Title: Calidus 914 Engine Air Filter - Optional Position For Hot Countries		
AG-SB-2020-06-C-EN		Compliance Category:
Applicability		A – MANDATORY B – RECOMMENDED C - OPTIONAL
Aircraft type & model: AutoGyro Calidus	Affected Serial number(s): Calidus fitted with the Rotax 914 engine operating in hot countries	
The maintenance manual to be referenced is this stated or subsequent issue.		As per AutoGyro website
This form is the response from AutoGyro GmbH either against a problem found in the product in service requiring a containment or rectification action, or as service information for aircraft modification incorporation. For help, contact AutoGyro on 49(0)5121 88056-00, or email airworthiness@auto-gyro.com.

Intake before modification

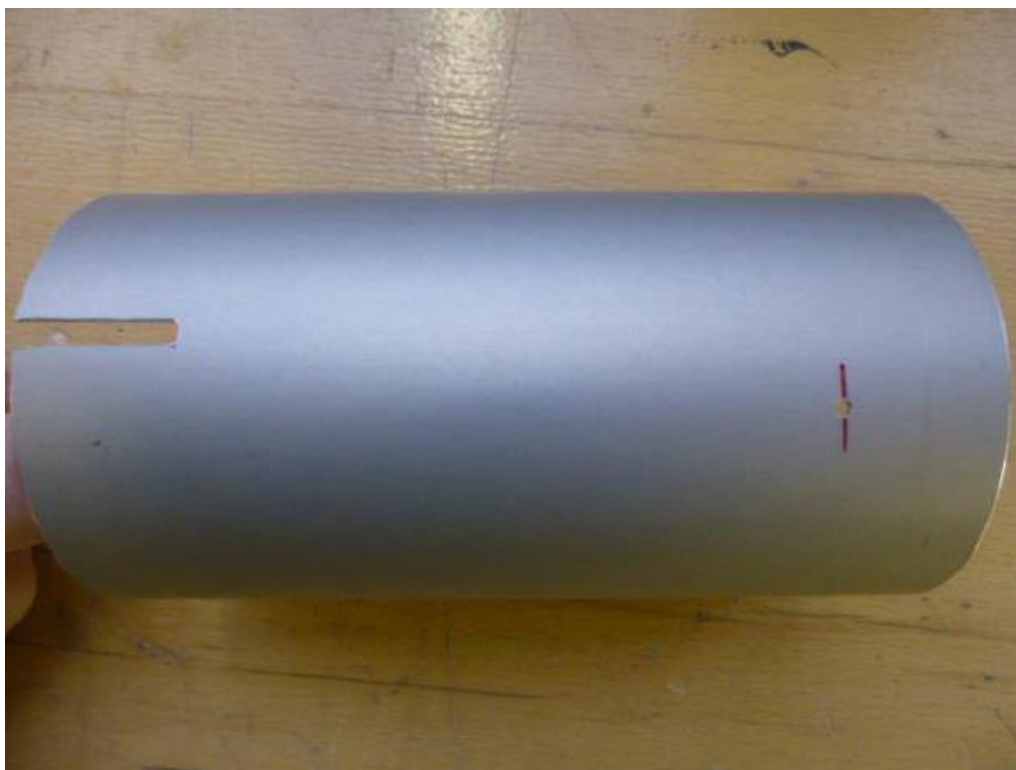
1. Remove the upper engine cowling and lower left engine cowling as described in the AMM Job Card 52-00-00 4-1.
2. Remove the existing air filter installation (Pic. 1) and cover the turbo inlet with a film of "gaffer" tape.

7. Remove the left engine cowling to allow final dressing and paint-finishing of the hole.
8. Mark the aluminium inlet tube 20mm from the plain end and drill a 2.5mm hole (Pic. 2)

9. Pre-assemble the inlet system, passing the safety-wire through the drilled hole, through the filter rim, and into one of the slots (under the pipe clip) (Pic.3).

10. Remove the temporary turbo-inlet protection and fit the inlet assembly to the turbo flange.
11. Pass the safety wire under the lowest clip on the vertical air delivery pipe, tighten the two new clips then pull the safety wire tight and join the ends with a crimped Nicoflex terminal. ***Note: All clamps, the air filter pipe and the air filter must be restrained by the safety cable.***
